Between 07 89 and 09 89 and from 06 90 the dampers for the tensioner have vulcanized lower rubber bearings.

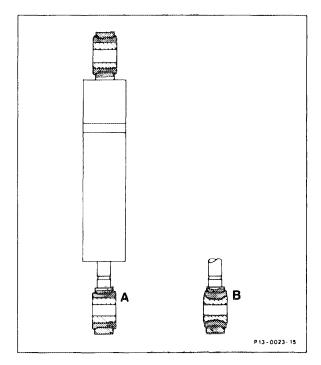
Pressed-on rubber bearing Vulcanized rubber bearing
